**Subject: Beaver Valley Power Station, Unit No. 1
Docket No. 50-334, License No. DPR-66
License Amendment Request No. 293**

Beaver Valley Power Station, Unit No. 1 License Amendment Request No. 293

Beaver Valley Power Station, Unit No. 1 License Amendment Request No. 293 REVISION OF RCS SPECIFIC ACTIVITY VALUE

FIGURE 3.4-1
DOSE EQUIVALENT I-131 Primary Coolant Specific Activity Limit
Versus Percent of RATED THERMAL POWER with the Primary
Coolant Specific Activity > 0.20 μ Ci/gram DOSE EQUIVALENT I-131

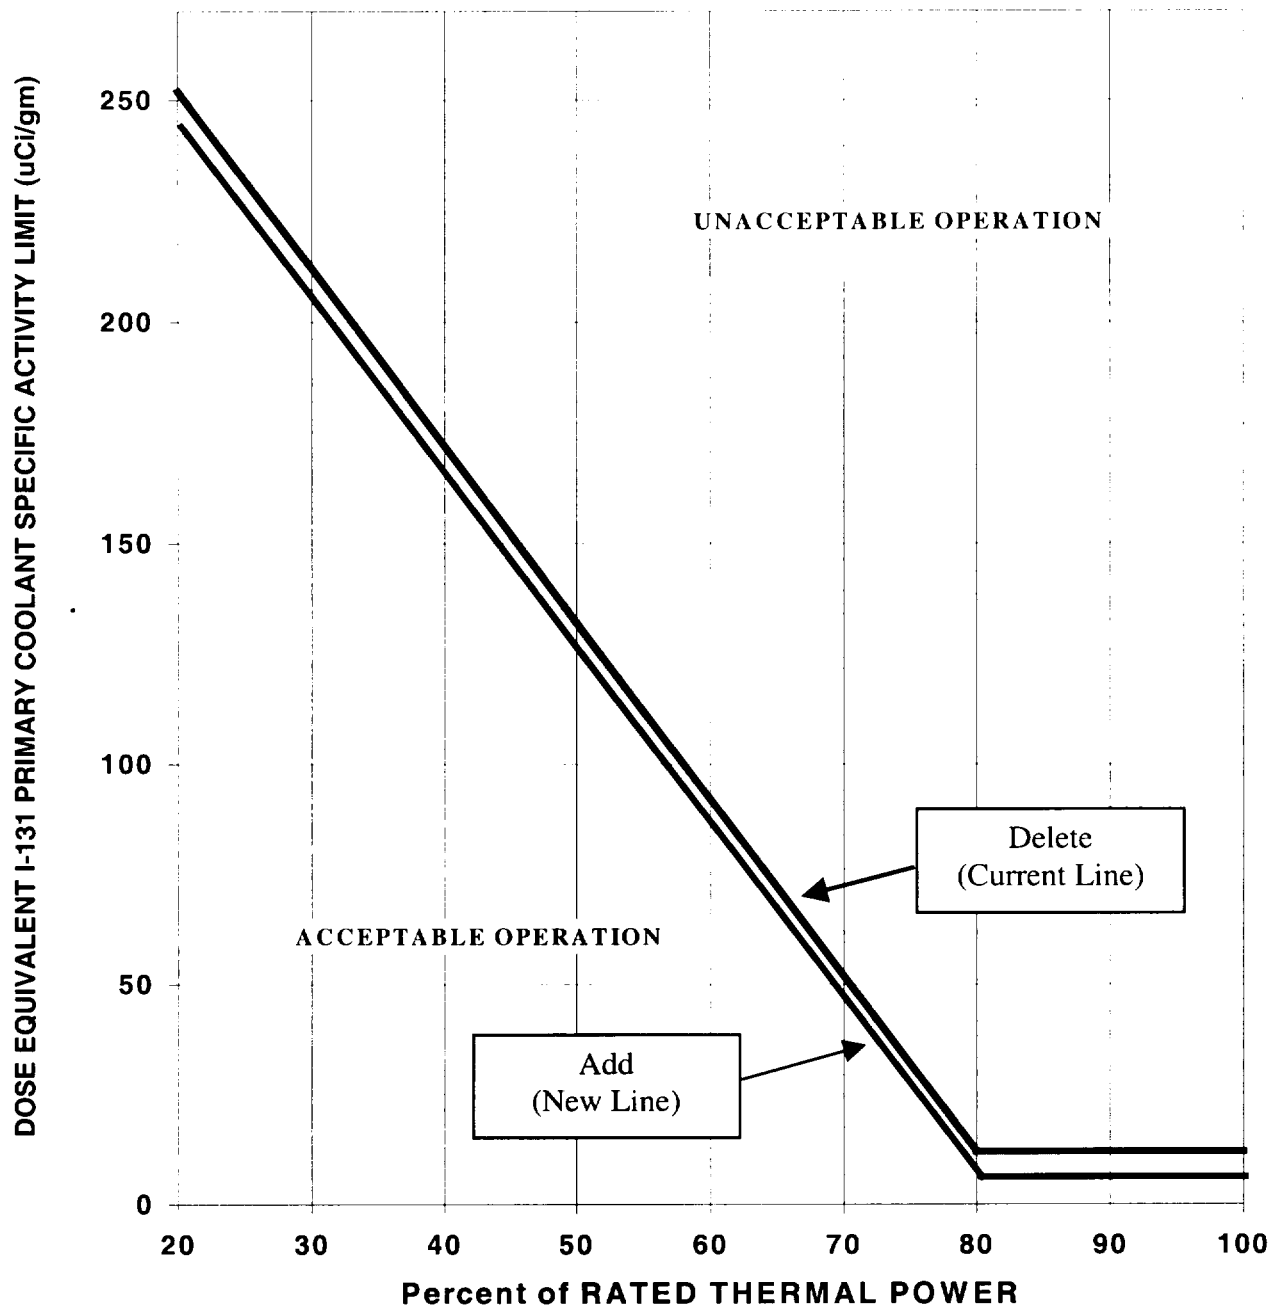
- a. With the specific activity of the primary coolant $> 0.20 \mu\text{Ci/gram DOSE EQUIVALENT I-131}$ for more than 48 hours during one continuous time interval or exceeding the limit line shown on Figure 3.4-1, be in HOT STANDBY with $T_{\text{avg}} < 500^\circ\text{F}$ within 6 hours.
- b. With the specific activity of the primary coolant $> 100/E \mu\text{Ci/gram}$, be in HOT STANDBY with $T_{\text{avg}} < 500^\circ\text{F}$ within 6 hours.

The ACTION statement permitting POWER OPERATION to continue for limited time periods with the primary coolant's specific activity > 0.20 $\mu\text{Ci/gram DOSE EQUIVALENT I-131}$, but within the allowable limit shown on Figure 3.4-1, accommodates possible iodine spiking phenomenon which may occur following changes in THERMAL POWER. Operation with specific activity levels exceeding 0.20 $\mu\text{Ci/gram DOSE EQUIVALENT I-131}$ for more than 48 hours during one continuous time interval or exceeding the limits shown on Figure 3.4-1 must be restricted to ensure that assumptions made in the UFSAR accident analyses are not exceeded.

0.10
